То:	All Parties on Record with the City of Somerville as Holding IFB $\#26\text{-}10\ 165$ Broadway Slab Remediation
From:	Felisa Gárate, Procurement Analyst
Date:	9/5/2025
Ù	uestions and Answers from Pre-Bid pdated Drawings (S001, S100, S200, and S400) pdated Exhibit A – Itemized Base Bid List (Unit Price Form)
	Addendum No. 1 to IFB #26-10
-	oroposal package. Failure to do so may subject the proposer to disqualification. E OF COMPANY / INDIVIDUAL:
ADDR	RESS:
CITY	STATE/ZIP:_
TELE	PHONE/FAX/EMAIL:
SIGN	ATURE OF AUTHORIZED INDIVIDUAL:
ACKN	NOWLEDGEMENT OF ADDENDA:
Adday	ndum #1 #2 #3 #4

CITY OF SOMERVILLE, MA Level 1 and Fire Escape Repairs and Maintenance ITEMIZED BASE BID LIST

LEVEL 1 AND FIRE ESCAPE REPAIRS AND MAINTENANCE

165 Broadway, Somerville, MA 02145

LEVEL 1 REPAIR PLAN

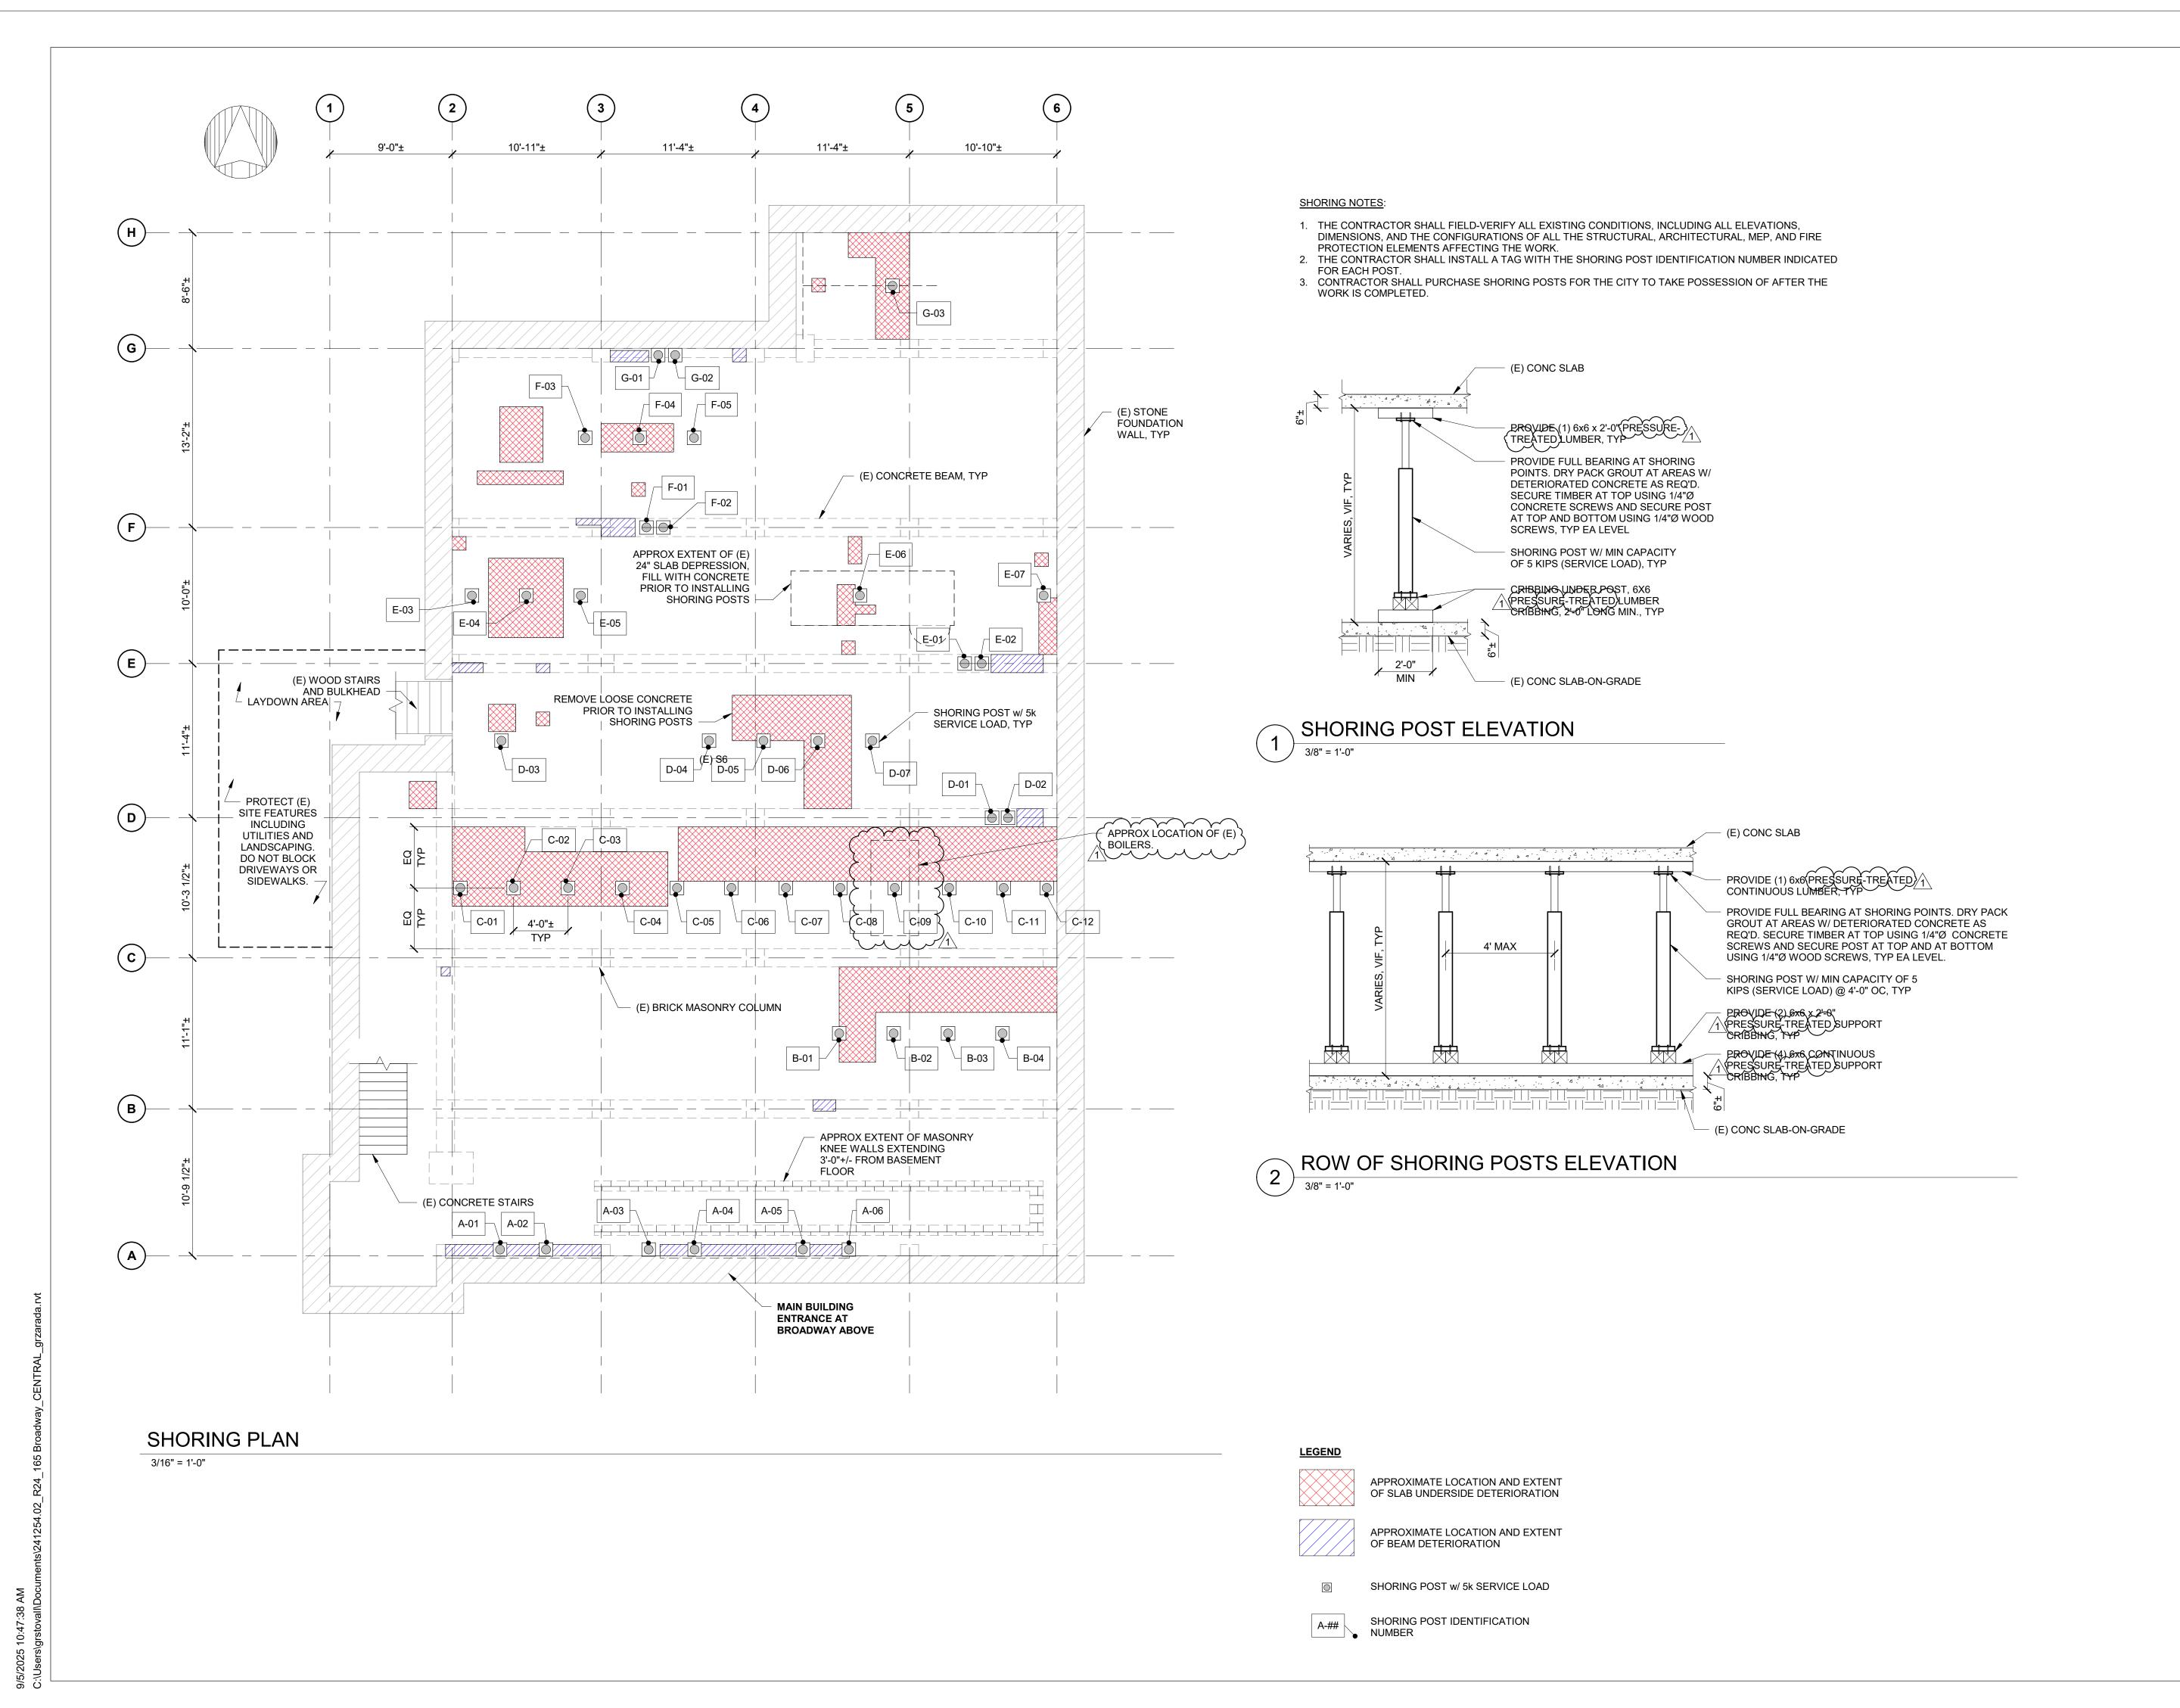
3.	Is permanent lighting required in the basement? Are outlets available?	The intent is for the contractor to provide construction lighting to remain after the project completion. Power is available, with some modifications. There are currently no outlets. The contractor shall be responsible for making any necessary modifications.

15.	Who identifies the repointing scope?	The Engineer will identify the repointing scope at the stone foundation walls on the brick masonry columns. Unit prices have been included for this work.

AS REQUIRED TO THE EXISTING SUMP PIT. 7. THE CONTRACTOR SHALL PROVIDE TEMPORARY LIGHTING TO REMAIN IN PLACE AFTER THE PROJECT COMPLETION.

LEVEL 1 SHORING PLAN

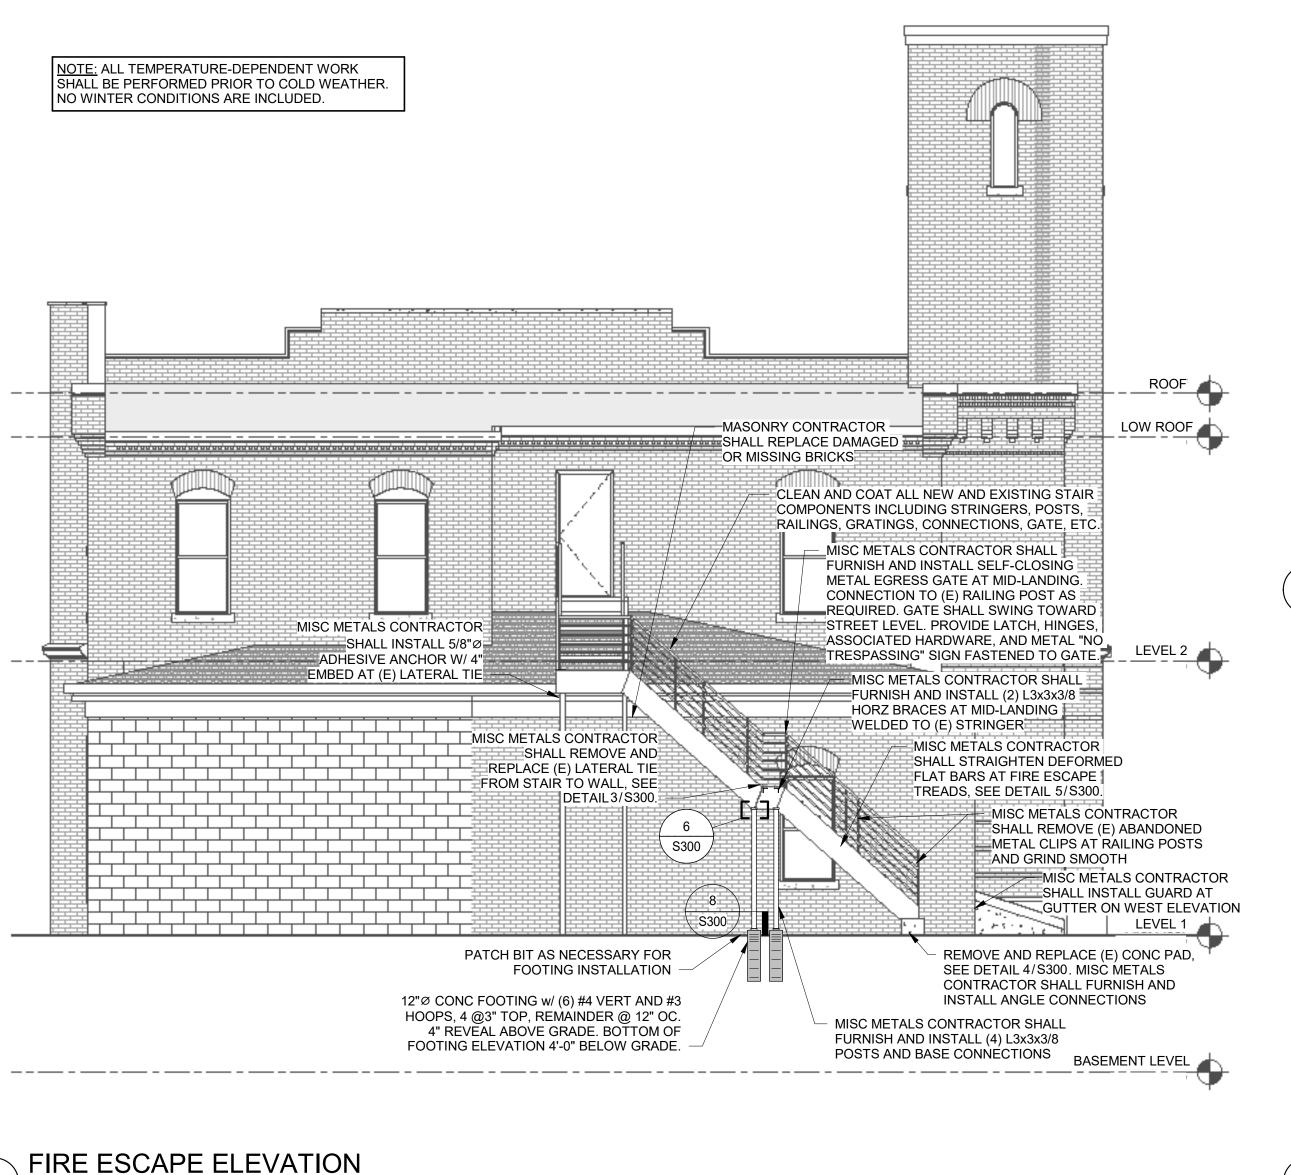
4.	Regarding shoring, is there cribbing? Does the wood need to be pressure- treated or fire-treated?	Yes, refer to S200 for cribbing requirements. The wood cribbing shall be pressure-treated. The wood is not required to be fire-treated, as this is a temporary condition.

SLAB ON GRADE DETAIL

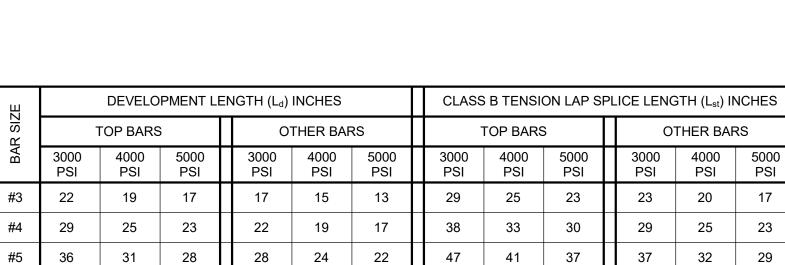
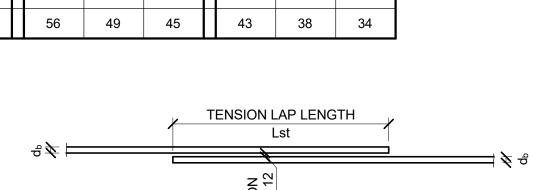
5.	When infilling the slab depression, is the intent to fill flush to the existing floor level? What is the fill material under the concrete?	The intent is for the finished surface to be flush with the existing floor level. The specified fill material is insulation, but compacted gravel is also acceptable.
